PLAN COMMISSION

January 11, 2021 @ 5:30 p.m.
Zoom Meeting:

BLOOMINGTON PLAN COMMISSION
STAFF REPORT – Third Hearing
Location: 300 W. Hillside Drive

CASE #: PUD-17-20
DATE: January 11, 2021

PROJECT NAME	PROJECT LOCATION	DATE
SWITCHYARD	WEST HILLSIDE AND THE BLIND	DECEMBER 28, 2020
DRAWN BY	PROJECT NO.	DRAWING SCALE
MAJOR BRUCE ARCHITECTURE & DESIGN	2020-0001	1" = 20'-0"
CONCEPT PLAN

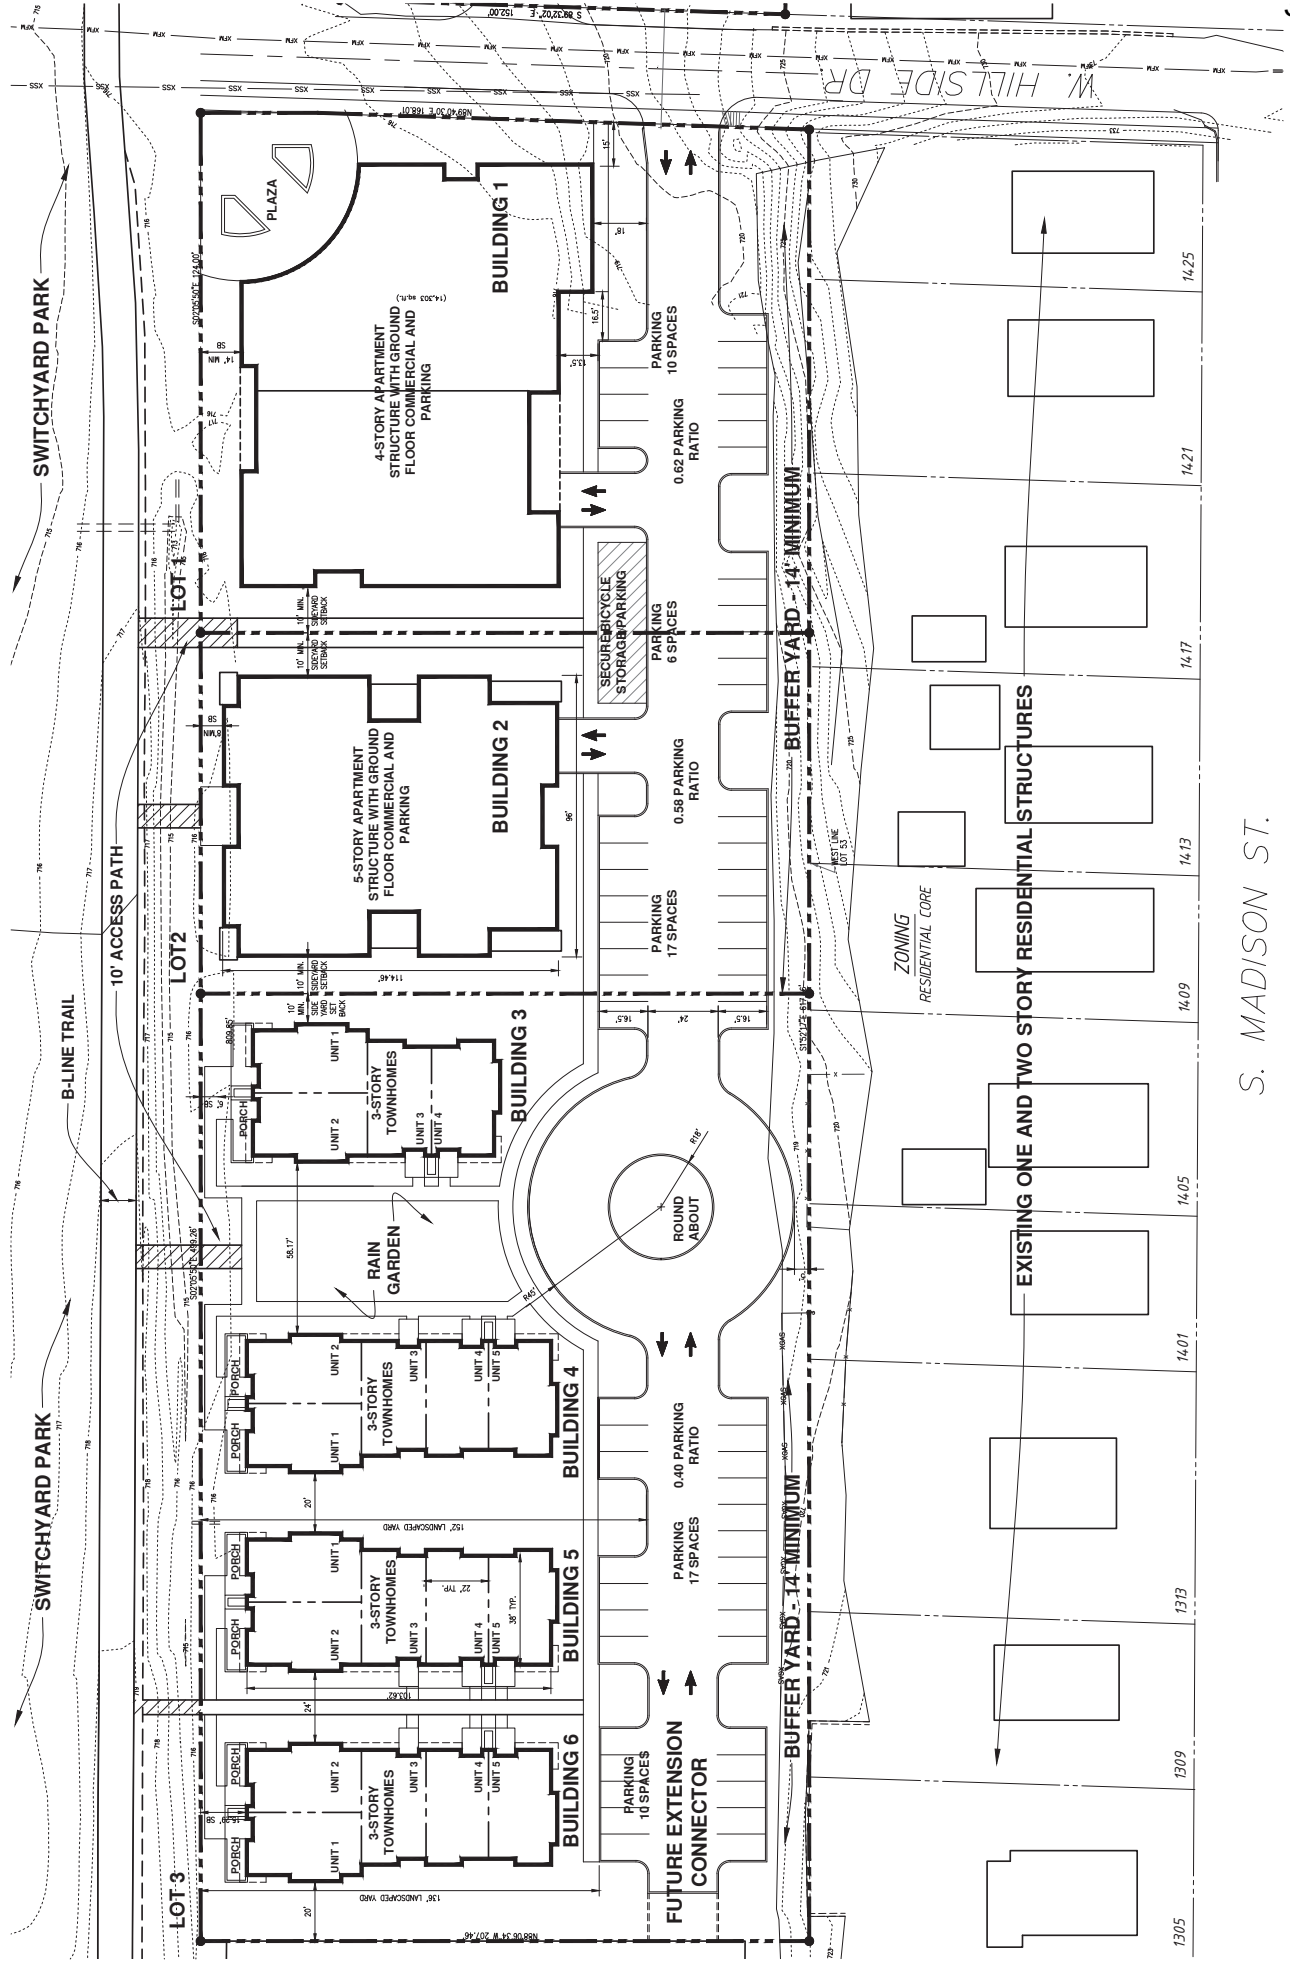
- The site plan for Building 7 does not represent access to the building from Hillside clearly.
 - Consider drop off/pick up zone
 - Accessible grades from entry to trail
 - Sidewalk connections

- The renderings appear to represent Buildings 4 and 5 to be much closer than the dimensions indicated on the provided site plans. We would not want them to be any closer than dimensioned.

- Current placement of the roundabout creates a zone of dead-end parking to the north, consider shifting this feature to the north end of complex. Shifting the roundabout and rain garden could provide additional buffer to the remaining warehouse to the north.
- The Site Plan indicates 16.5' parking spaces with a 24' drive aisle, this could become congested if larger vehicles utilize the parking spaces.
- Hillside Drive currently dead ends at the trail.
 - The park master plan indicates Hillside as a pedestrian entrance.
 - Consider terminating the roadway asphalt at access points to Building 7 and treat the remaining zone towards the trails as pedestrian only – potential partnership of developer and city.

BUILDING 7 PROPOSED ELEVATIONS

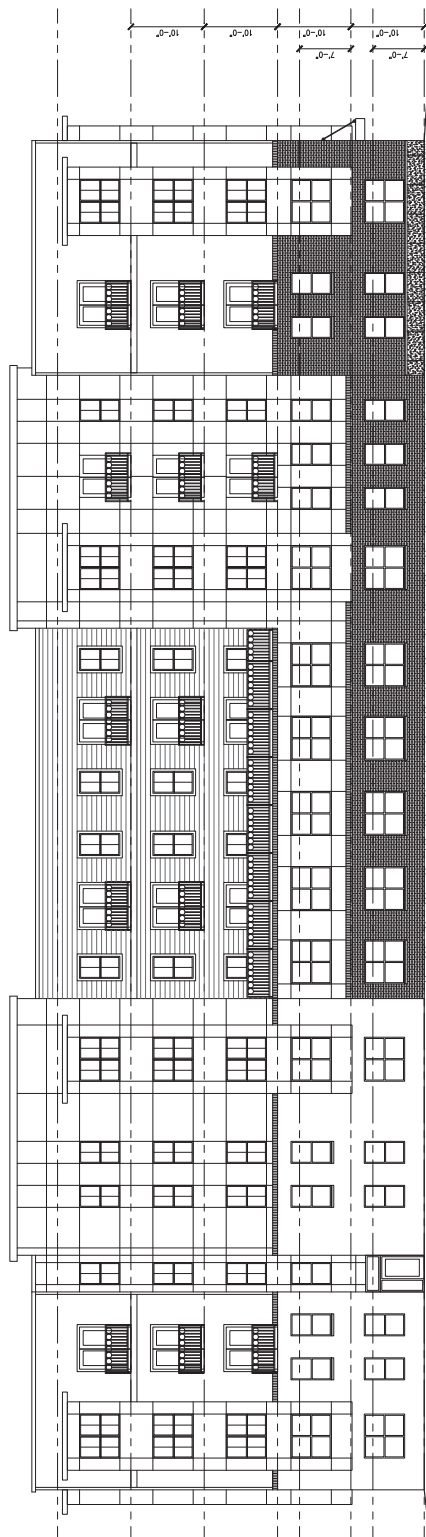
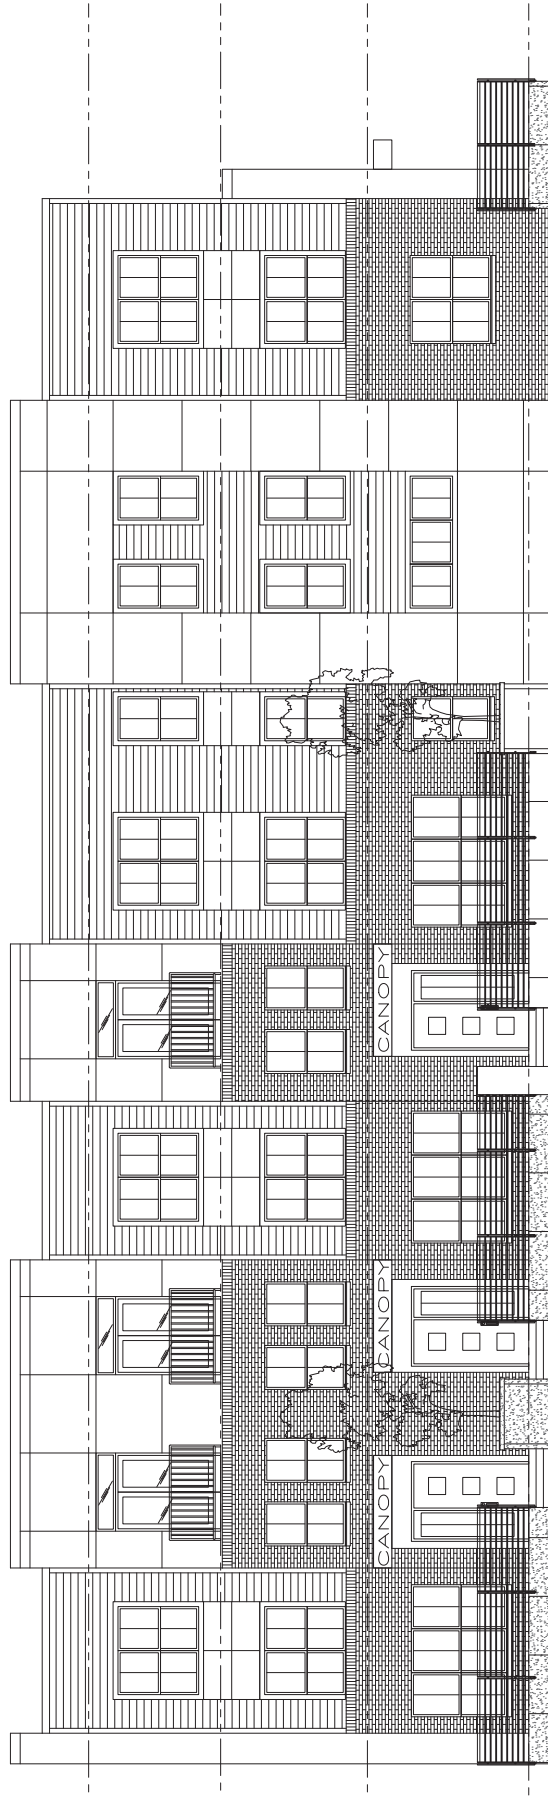
The Department has two concerns regarding the proposed standards for the building south of Hillside Drive. First, the District Ordinance proposes a 100% maximum impervious surface coverage allowance for the property. The Department does not support this specific standard and recommends that this be adjusted to a maximum 80% and a minimum 20% landscape area, which matches the standards proposed for the other two commercial lots. Second, the petitioner is proposing to allow a 5-story building. The Department is concerned about the height of this building since it is closer to the neighborhood than the two other buildings of similar height located on the other parcel to the north. This building is only three floors of dwelling units and the bottom two floors are strictly parking. The Department recommends that the maximum height of this building be limited to 4 stories or 50'.

The Department is still concerned about the bottom two floors of building #7 proposed south of Hillside Drive, however with the bottom floors being used for parking garage there is little that can be done to improve that portion of the building. The bottom two floors of that building still consist entirely of parking with no active ground floor use, especially along the Park façade. An additional area of concern regarding Building #7 involves the proposed height and massing of this building adjacent to the single family neighborhood. This concern is also reiterated in the review memo from Schmidt and Associates. Unlike the other two multi-family buildings (Building #1 and #2) to the north, there is not a drive aisle and parking area and large buffer to separate the massing of those buildings from the single family residences. The Department believes that a 5-story building adjacent to the residences is not appropriate and has recommended a condition of approval to limit the height of Building #7 to 4 stories or 50’.

2. The District Ordinance shall be amended prior to allow a maximum 80% impervious surface coverage and minimum 20% landscape area for the Lot with Building #7 and the maximum height of that building shall be limited to 4 stories or 50’.

3.) ROAD CONNECTION:

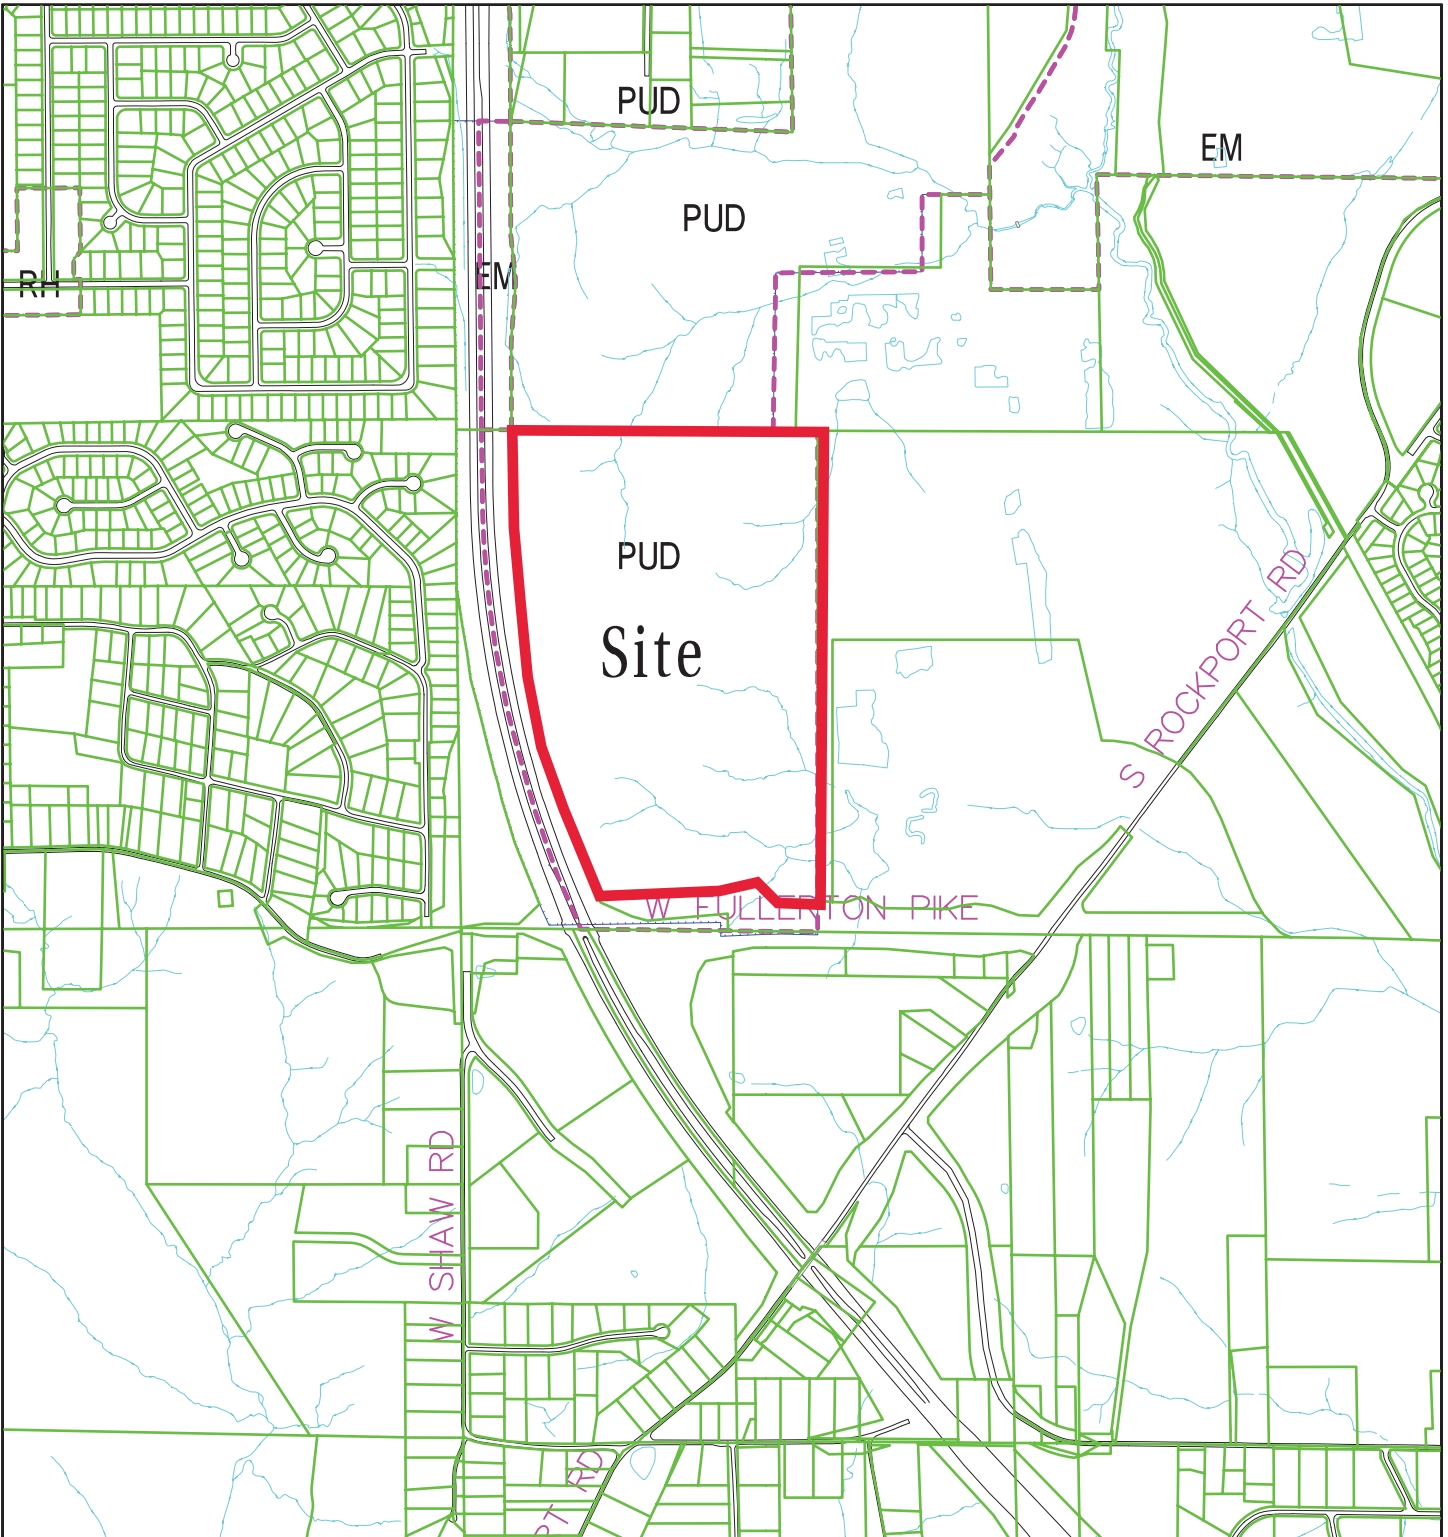
The EC is not in favor of the future road stubbing into the adjoining woods at the location shown on the plans. In the past, there was much discussion regarding saving the mature woodland to the north of this property. The EC would still recommend protecting that woods.
